COUNTY OF RIVERSIDE
TRANSPORTATION DEPARTMENT

RESURFACING & WIDENING PROJECT
CORYDON STREET TO BONNIE LEA DRIVE

PROJECT No. C4-0074

ADDENDUM NUMBER 1

606-3

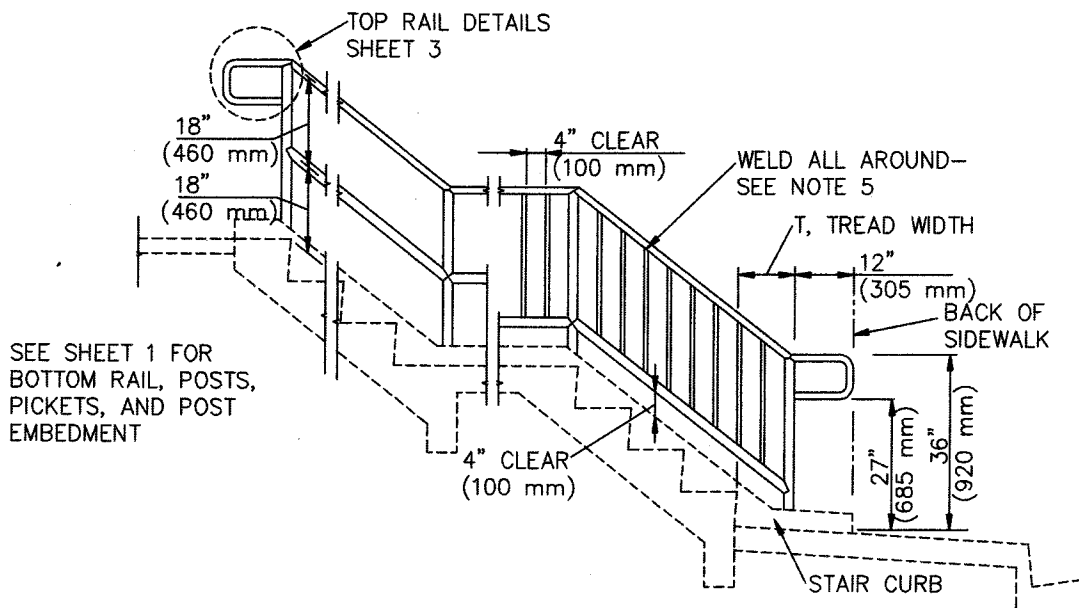
Refer to section "Pipe Hand Railing" on page 59 of the Special Provisions. Delete this section and Replace with the following:

Metal Hand Railing shall conform to the Metal Hand Railings APWA standard 606-3, and Standard Specifications Section 83-1.02A, and as shown on the plan, and these Special Provisions and as directed by Engineer.

SECTION A-A

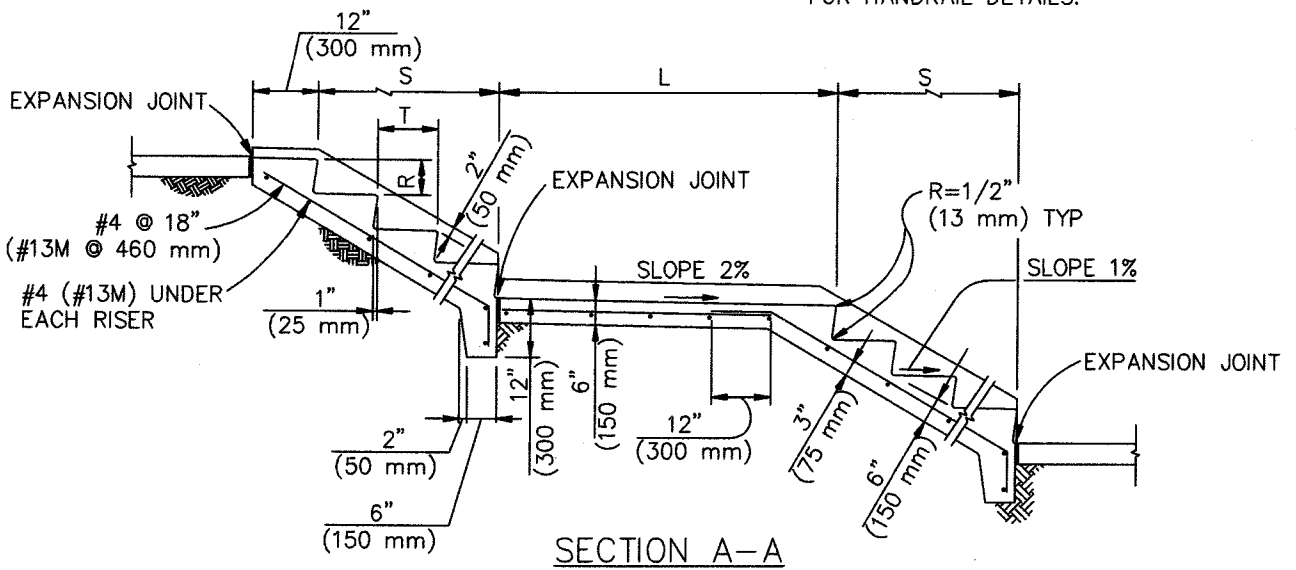
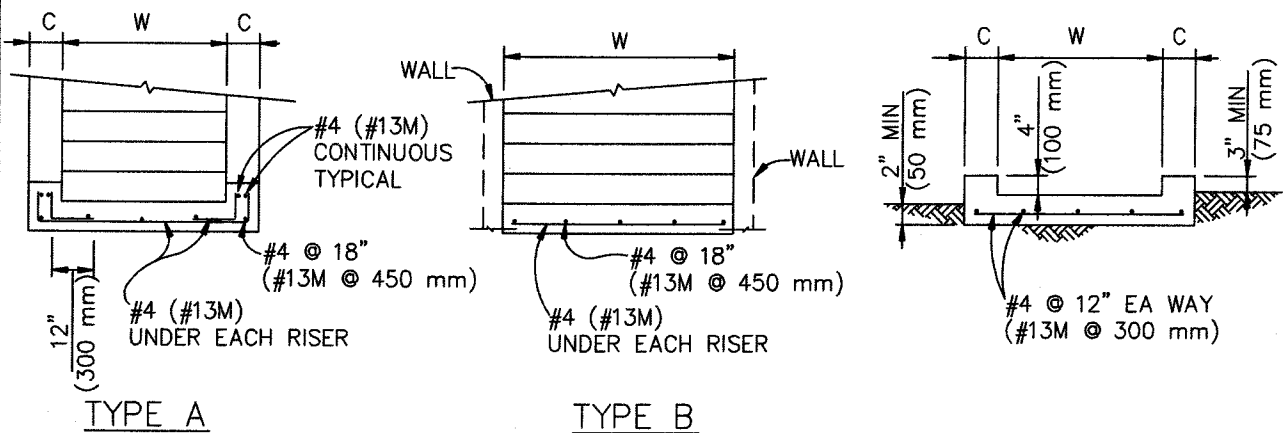
Contractor shall construct following additional minor concrete structures as shown on the plans and in conformance with applicable standard Specifications and as directed:
